“Request for Bids” – FY 15/16 OLD FILTER PLANT, DEMPSEY BOOSTER STATION, AND 5MG TANK SITE IMPROVEMENTS PROJECT CIP # 3041A

RFB #15/31/B

Addendum No. 1 – Change in bid due date. Clarifications following the Pre-Bid Conference held June 11, 2015.

Adapters

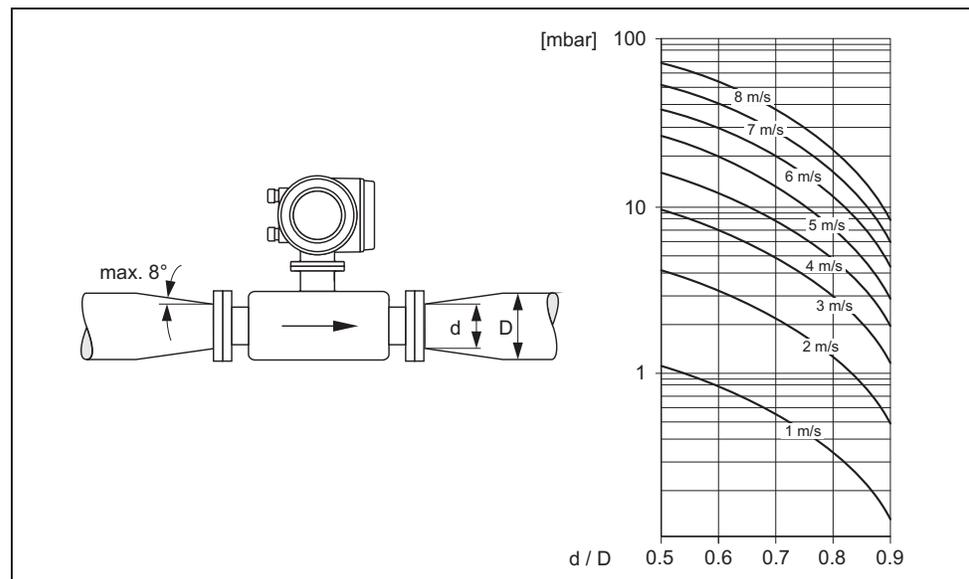
4. Please see attached PROMAG meter data sheet for more information regarding General Note #16 on sheet (2 of 6).
5. Plan sheet (6 of 6), ‘Meter Vault Details’ requires the installation of both a dismantling joint and a D.I.P. Coupling. There will be no changes made to this requirement in the plans. It is the intention of the City of Santa Fe to have both fittings installed.

Suitable adapters to DIN EN 545 (double-flange reducers) can be used to install the sensor in larger-diameter pipes. The resultant increase in the rate of flow improves measuring accuracy with very slow-moving fluids. The nomogram shown here can be used to calculate the pressure loss caused by reducers and expanders.
